Heckington Fen Solar Park

Appendix 6 – Change consultation information leaflet

Document Reference: Pre-ExA.ChangeApp.CCRApp6.V1

Change Notification Consultation– Information Leaflet

-  Proposed Order Limits
-  AW1 extension for bus-coupler
-  AW2 extension for new CSE*
-  Accepted DCO Order Limits

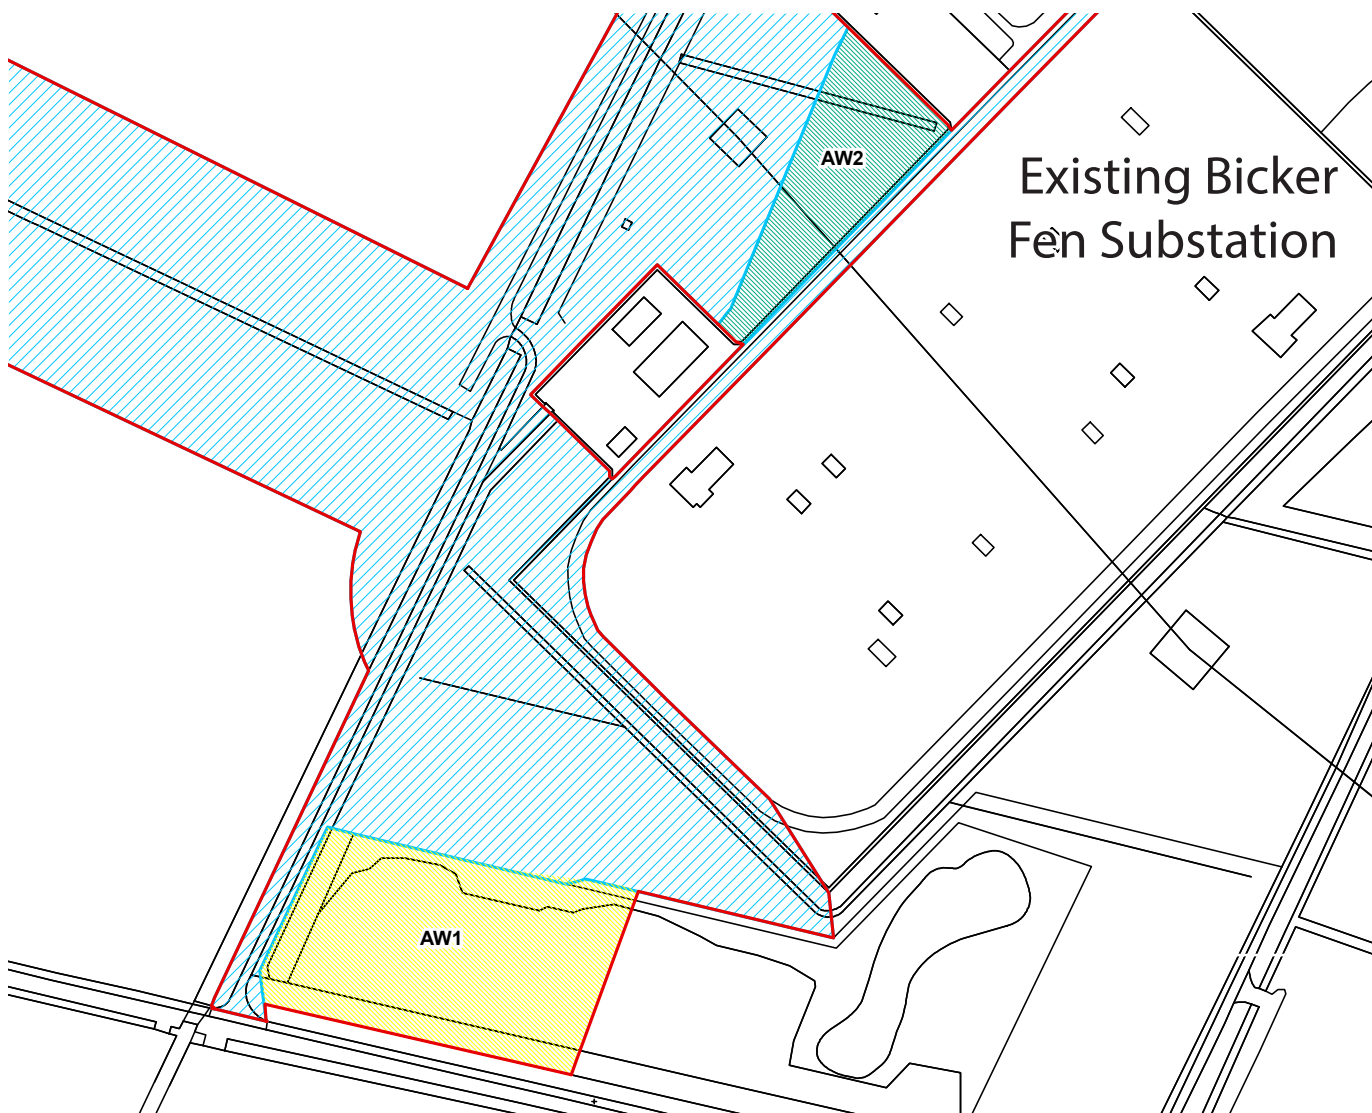
- a new section of NGET infrastructure at the substation comprising a busbar extension including a section breaker, a bus coupler and a feeder circuit on land to the south of Bicker Fen Substation (AW1) ; and
- a new cable sealing end compound (CSE) on land to the west of Bicker Fen Substation (AW2); together known as, the "Additional Works".

Accordingly, a larger area (of approximately 0.9ha) is needed to deliver the Additional Works and to facilitate the Applicant's connection into the Bicker Fen Substation. The full extent of the land area covered by the change is shown in yellow and green hatching on plan overleaf.

The extent of the trees which need to be cleared to enable the necessary expansion at Bicker Fen can be seen on the plan below (yellow area). NGET have advised that all of the plantation within AW1 would need to be cleared if an Air Insulated Switchgear (AIS) solution is used. NGET have also advised that some of the plantation woodland would need to be cleared for the Gas Insulated Switchgear (GIS) solution but this would be more limited. This design solution would be a continuation of the switchgear equipment already in operation at Bicker Fen National Grid substation. The alternative design option is the installation of a Gas Insulated Switchgear system (GIS). This alternative solution would be housed within a building and would occupy a smaller footprint than the AIS design option.

The cable sealing end (CSE) compound on land to the west of the existing Bicker Fen Substation (green area AW2) is a connection point to transition between underground cable and above ground apparatus such as electrical bus-bars or overhead line. At Bicker Fen Substation there is a 400kV transmission tower on the western boundary of the substation site which carries overhead line circuits to West Burton. As part of facilitating the Applicant's connection, one of the West Burton circuits will be moved to terminate at a new bay that will be constructed as part of the Bicker Fen Substation extension. To achieve this, the overhead line circuit will be connected onto a new CSE to be located in the area adjacent to the tower and an underground cable run to the new bay. For this reason, the Order Limits need to be extended around the transmission tower to allow for this circuit transfer.

In addition, NGET require optionality over the type of insulation required for the switchgear and so the relevant parts of Work No.6A and 6B in the revised DCO will be updated to include the option for Air Insulated Switchgear (AIS) or Gas Insulated Switchgear (GIS).
